UNITED STATES PATENT AND TRADEMARK OFFICE

APPLICATION NO.	FILING DATE	FIRST NAMED INVENTOR	ATTORNEY DOCKET NO.	CONFIRMATION NO.
10/054,257	01/22/2002	Frederick R. Bean	TN-2239	3692

Office Action Summary

DETAILED ACTION

Fig. 6

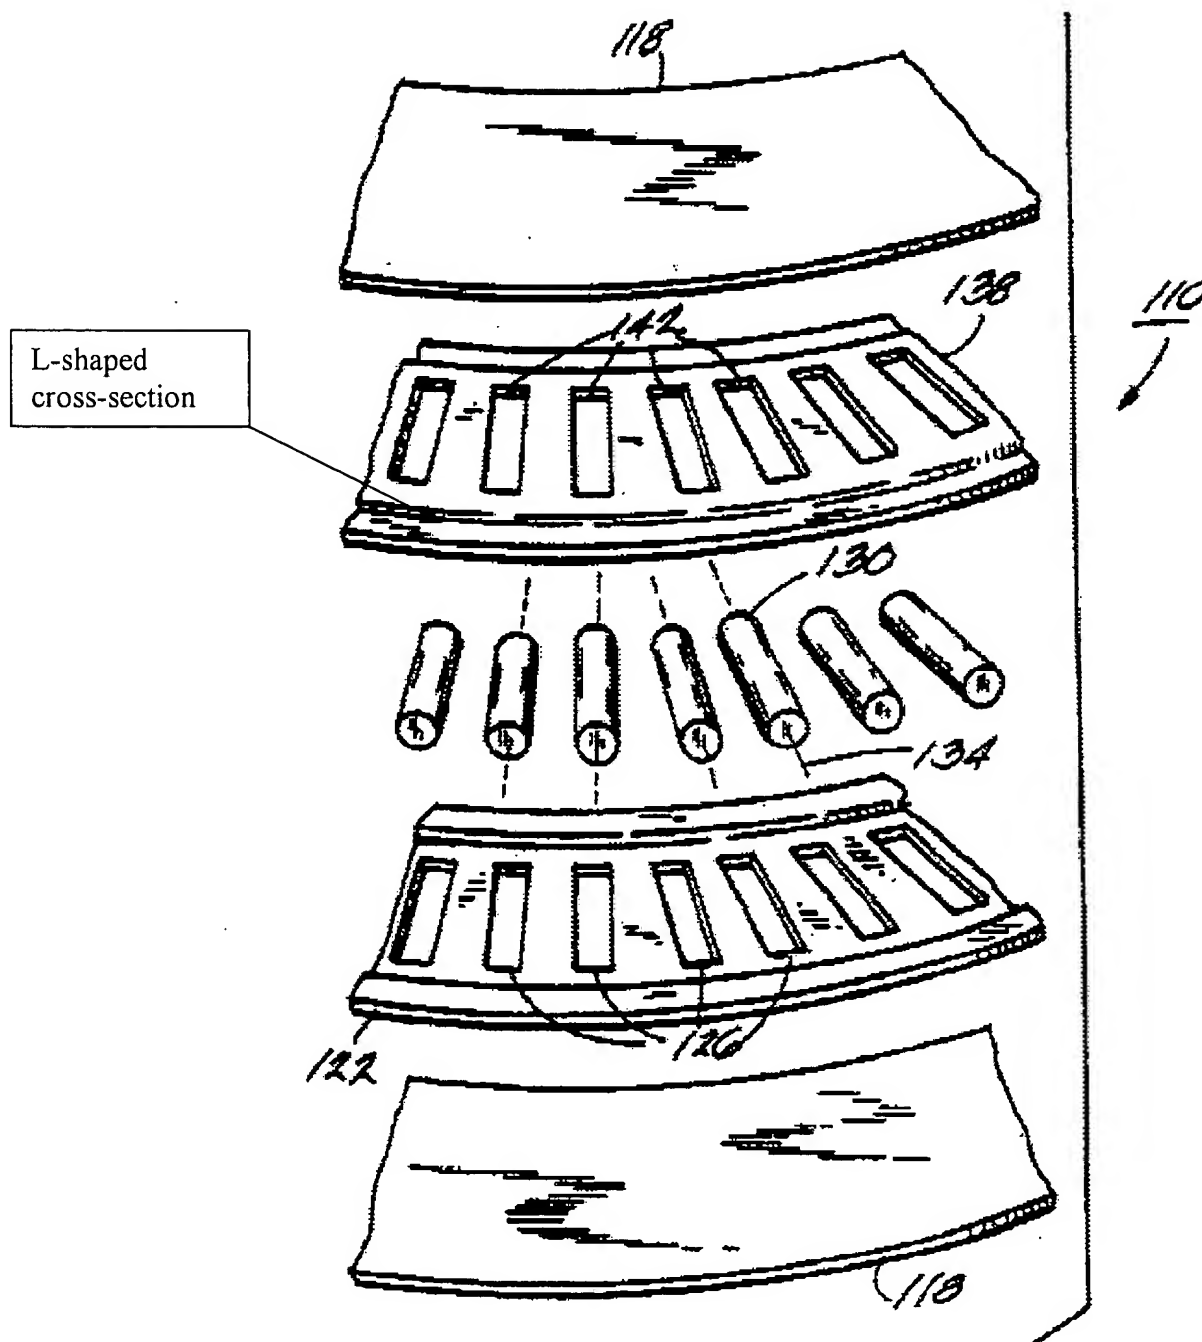
Regarding claims 1-5, Brault teaches a saw assembly comprising a base 14 having a circular well 66, a table 182 rotatably attached to the base, a saw assembly 150 and a wearing ring 138 having a L-shaped cross-section. See Figs. 1 and 5-7.

Regarding claims 6 and 7, a wall 106 extending from the well is best seen Fig. 5.

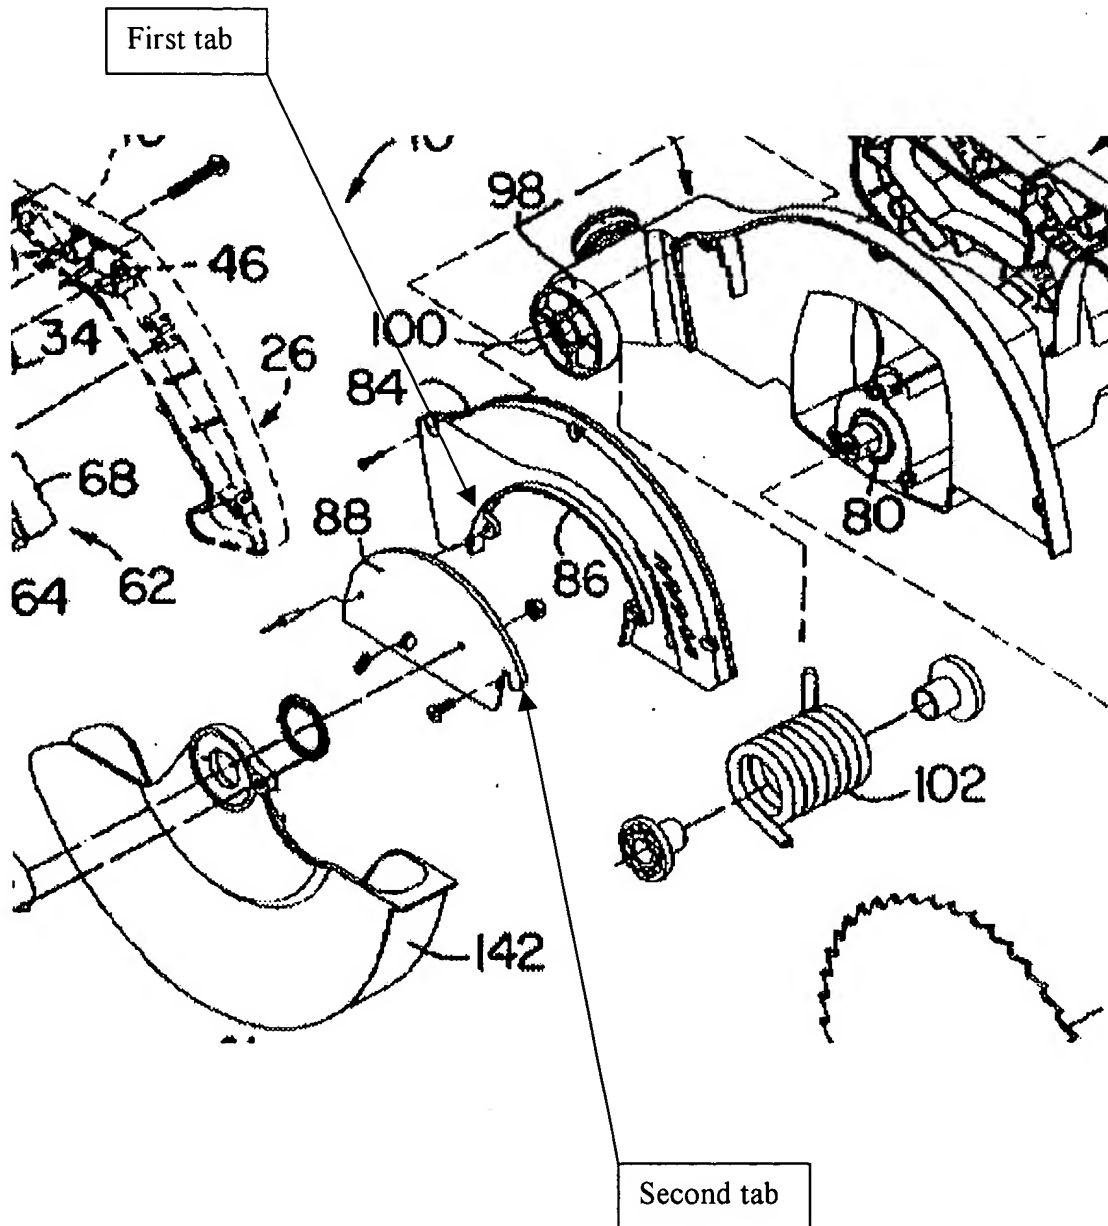
Regarding claim 13, Chen teaches a chop saw assembly comprising a base assembly and a saw assembly. The saw assembly comprises an upper blade guard 84, a plate 88 and a lower blade guard 142. A screw secures the plate 88 to the upper blade guard 84.

A first tab on the upper blade guard 84 extends outwardly near the screw. The thickness of the first tab is the first distance. It is inherently to unscrew the screw a distance longer than the first distance to pivot the plate 88. See Figs. 1 and 3.

Regarding claims 14-16, a second tab on the plate is best seen in Fig. 3.
